## TECHNICAL NOTE TN-932

### TM8000 Mobile Radio Hardware Update and Firmware Requirements

This Technical Note applies to the TM8100 and TM8200 mobile radios.

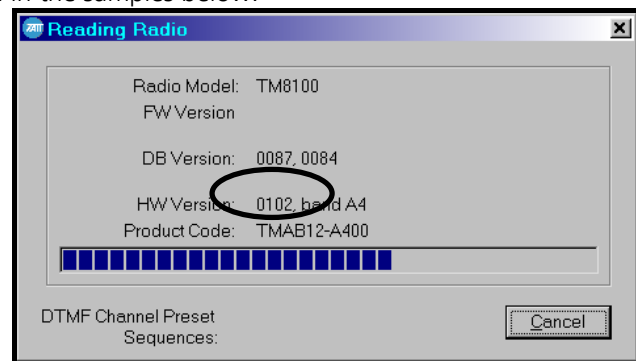
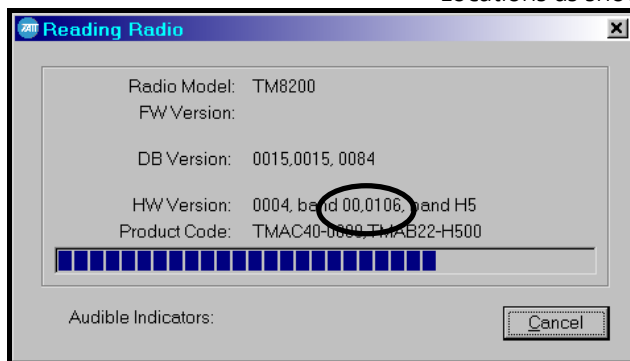
These changes can be noted on the bottom left of the box labels by the hardware version number(s):

H/W 0102 – TM8100

H/W 0108 – TM8200.

These hardware strings also appear in the Programming Applications. Locations as shown in the samples below.
